Submission from the Building and Construction Department of the City University of Hong Kong

Figure 2 Noise barrier with insufficient Length at Lung Cheung Road

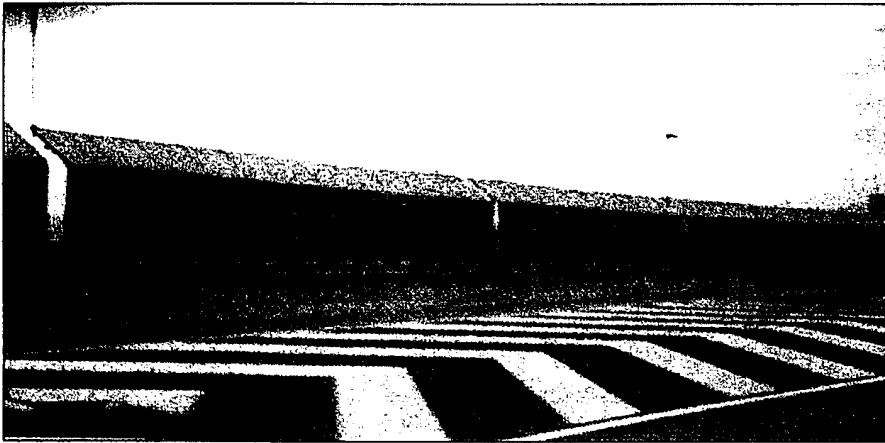
It was found that many existing barriers that were not improperly designed and installed could not achieve their expected noise reduction due to insufficient height, insufficient length, and gaps (see figures 1 to 3). In order to ensure that the residents do get the benefits from the programme, some suggestions are listed below.

- The detail design and on-site installations must be approved by qualified acoustic engineers to ensure the effectiveness of noise barriers.
- There should be a post-commissioning test to ensure whether the noise barriers can achieve their design noise reduction capability for future design reference.
- It should be performed by independent laboratory with recognized quality assurance certificates. (that has been implemented in most civil projects but not required in previous barrier projects in which only the overall barrier length and height were checked.)
